PUC DOCKET NO. 42087

APPLICATION OF ONCOR ELECTRIC
DELIVERY COMPANY LLC TO AMEND
A CERTIFICATE OF CONVENIENCE
AND NECESSITY FOR A PROPOSED
138 KV TRANSMISSION LINE IN
DENTON, TARRANT, AND WISE
COUNTIES, TEXAS

**RESPONSE OF ONCOR ELECTRIC DELIVERY COMPANY LLC
TO TODD GROUP'S FIRST REQUEST FOR INFORMATION**

REVISÉ D

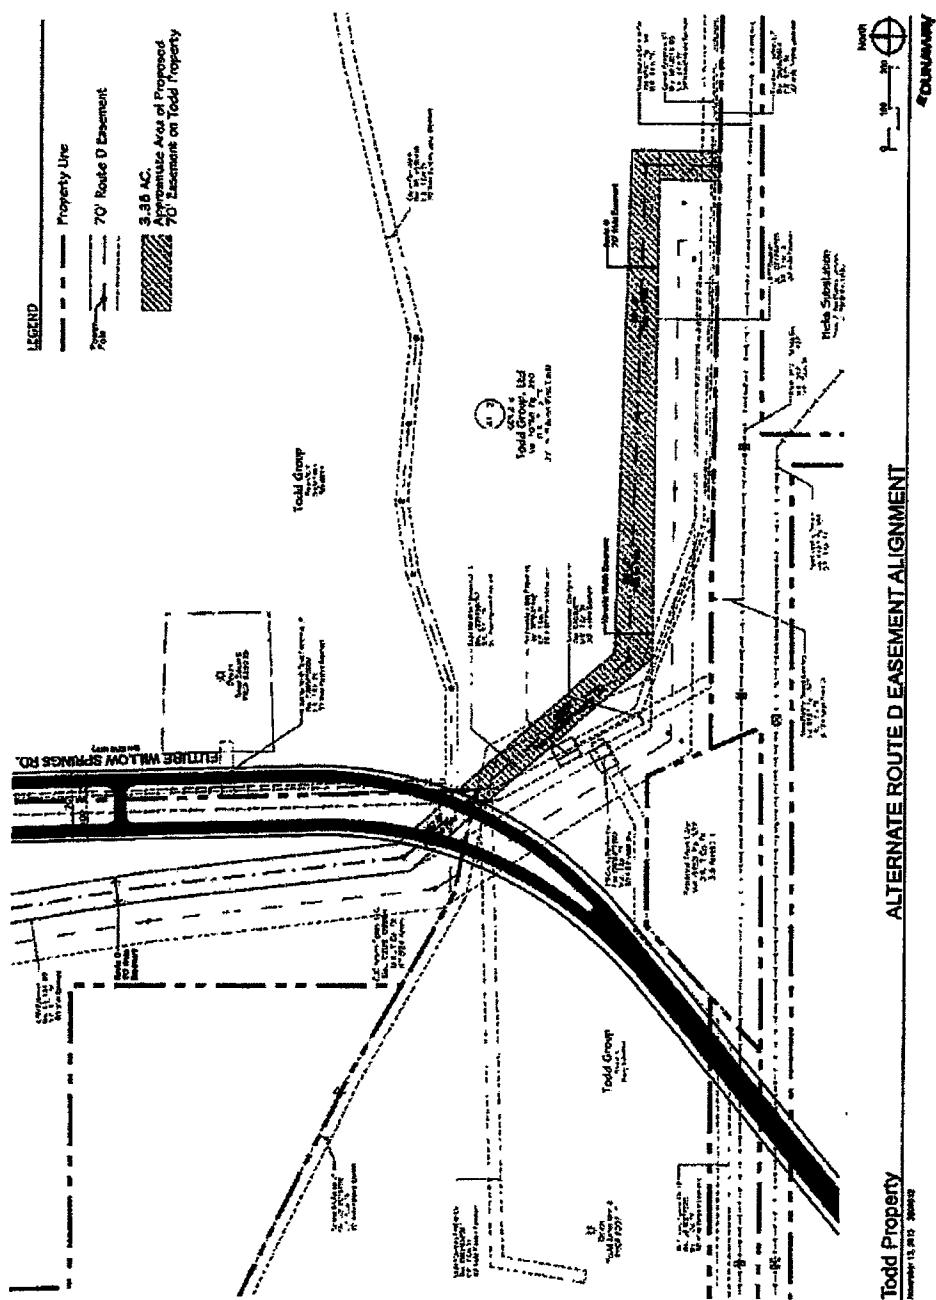
Todd Group submitted a modified route location as identified on the attached Exhibit titled "Revised D." Please state the general factual bases that support your reasons, if any, why the current proposed Link D could not be modified as per the attached exhibit.

Oncor cannot state whether the modification to Link D, as proposed in the attached Todd Group's Revised D Exhibit, is feasible until on-the-ground surveys can be performed. Should a route be approved by the PUC containing Link D, Oncor will cooperate with Todd Group concerning the placement of Link D across their property in order to minimize the impact of the proposed transmission line.
